Street Tree Review Panel Report for A38 Bromsgrove Route Enhancement Programme (BREP) Scheme 6

Summary of Scheme 6 Proposals:

Comments from Street Tree Review Panel

Figure 2: Scheme 6 Tree Consultation Plan

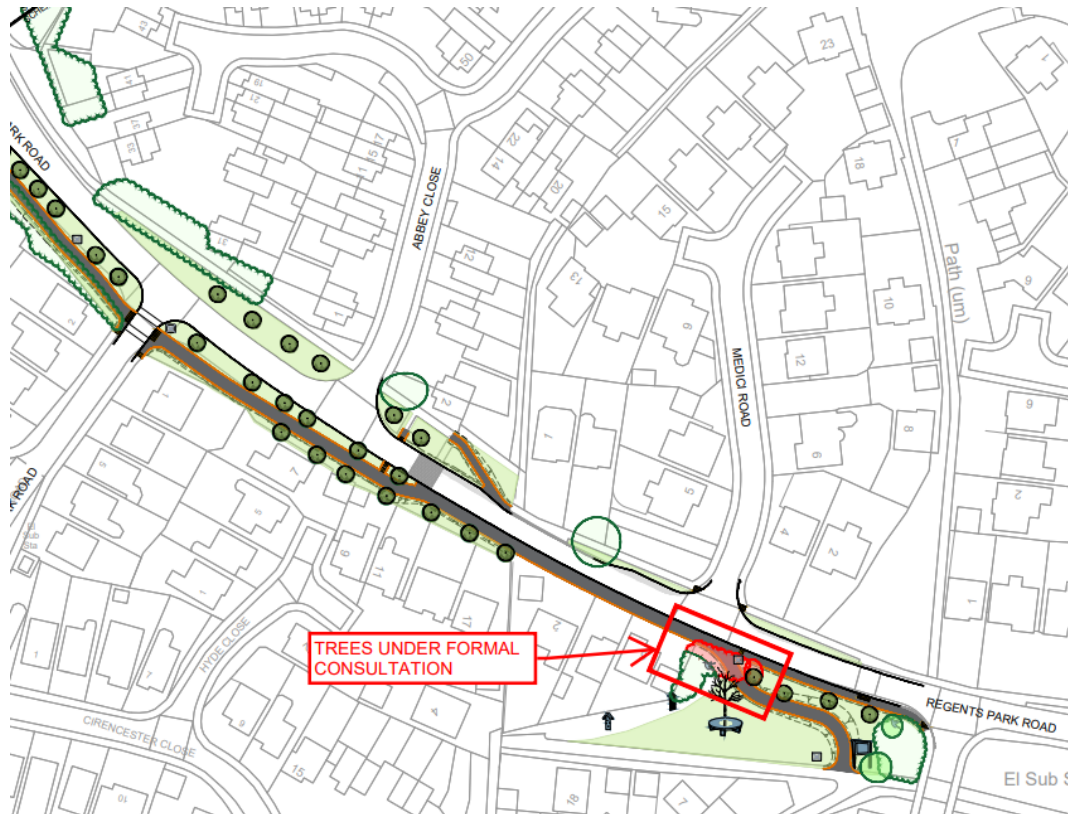
Figure 2 is an excerpt from the Scheme 6 consultation plan, showing the location of the small area of tree clearance and landscape proposals at the eastern end of the scheme, adjacent to Royal Worcester Crescent. None of the trees highlighted for removal have a Tree Preservation Order (TPO). Figure 3 is a zoomed in excerpt from the designers landscaping clearance plan and its interaction with the proposed cycleway.

Figure 3: Regents Park Road (East) Vegetation Clearance

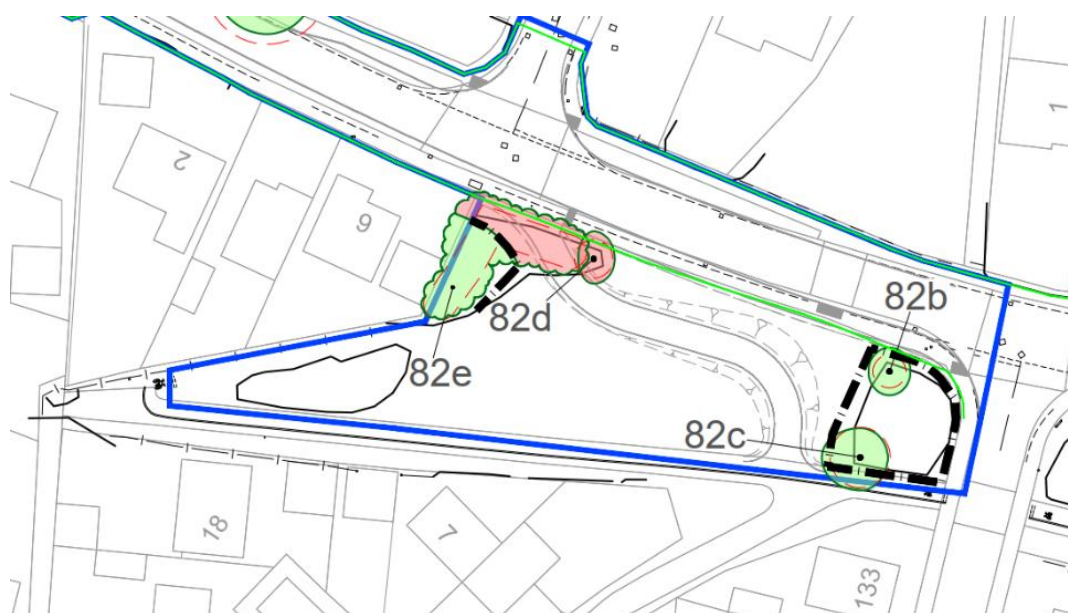
As shown in Figure 3, the scheme proposes a section of new cycleway to connect the active travel corridor along Regents Park Road to the existing corridor adjoining Brierley Road which is being improved as part of Scheme 3. Thus the reason why the shrubs and trees are proposed for removal are:

1. They are in the way of proposed works and/or working area to safely build the works. The shrubs/trees would cause great difficulty in delivering the works safely due to their location.

WCC instructed the designer to explore moving the start of the segregated footway/cycleway to the east, in order to avoid the need for vegetation clearance. Whilst the designer deemed this possible, in both a 2D and 3D arrangement, the shared footway cycleway would still have an impact on these trees and to avoid impacting them completely meant narrowing the shared route to 2.5m wide, less than the 3.0m required by LTN 1/20. Additionally, several metal statutory undertaker cabinets, which have been installed since the survey was completed, would conflict with a cycleway which went around the end of the treeline, see below. We believe these pose a risk to errant cyclist and thus moving the cycleway closer exacerbated the hazard.

To make this option feasible, the cabinets would have to be relocated by a significant distance to provide a suitable offset from the edge of the cycleway, whilst also allowing for the cycleway to avoid the trees. To move these boxes would require a lengthy process with the statutory undertaker as well as a sizeable payment for them to undertake the works, estimated to be a five to six-figure sum. Such a cost would make this scheme unfeasible and therefore, this option has not been pursued.

Thus the decision was taken not to pursue the option to relocate the cycleway due to the safety implications to users caused by the sub-standard shared footway/cycleway width and proximity to the adjacent cabinets, and the excessive cost to accommodate a safe alternative. No other alternatives were deemed appropriate without requiring more extensive tree and vegetation clearance.
